# CITY OF BELOIT

## REPORT TO THE BELOIT LANDMARKS COMMISSION

**File Number:** COA-2014-04

**Location:** 628 Harrison Avenue

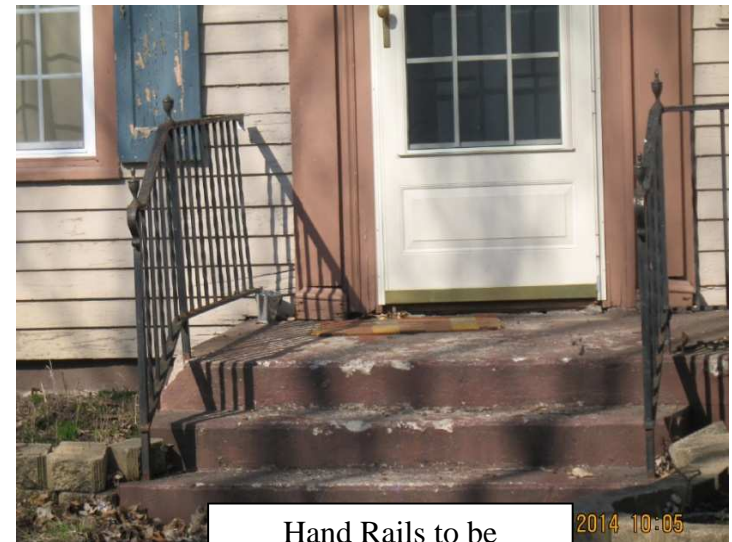
Front of House

Back of House

Hand Rails to be Replaced

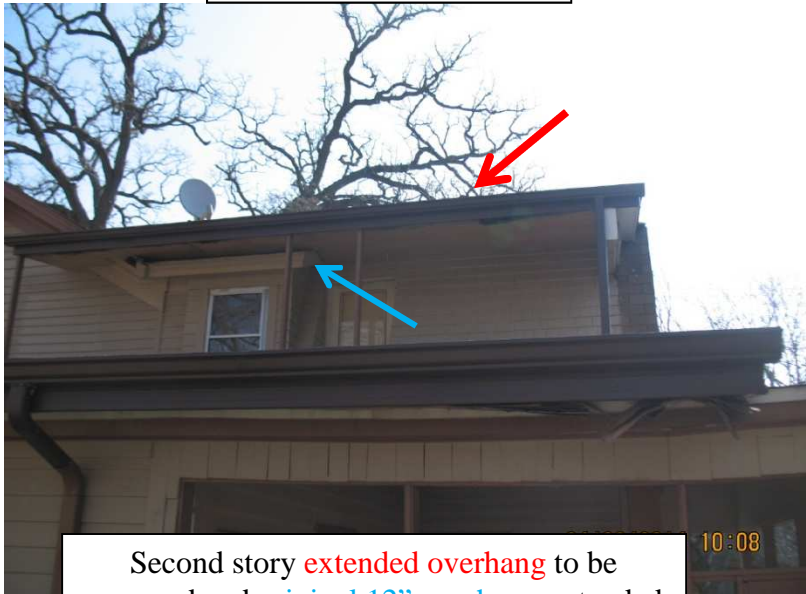
Fence to be Replaced  
(side of house)

Neighboring Fence

Fence to be Replaced  
(between garage and house)

## 2ND FLOOR OVERHANG & ROOF - for 2nd Story of Roof

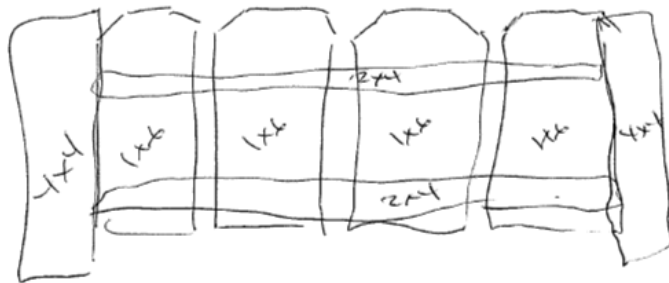
REMOVE AND REPLACE 2ND STORY EXTENDED OVERHANG WITH NEW 12" OVERHANG TO MATCH EXISTING SOFFIT AND FASCIA WILL BE WOOD ON 2ND STORY TO MATCH EXISTING SOFFIT & FASCIA. ANY SIDING TO BE REPLACED WILL BE SHAKE STYLE TO MATCH. ROOF TO BE ASPHALT 30 YEAR  $\frac{1}{2}$  SHAKE (APPROX 1800SF) TEAR-OFF OLD & REPLACE DECKING w/  $\frac{7}{16}$ " OSB. BROWN TRIM WILL BE USED.
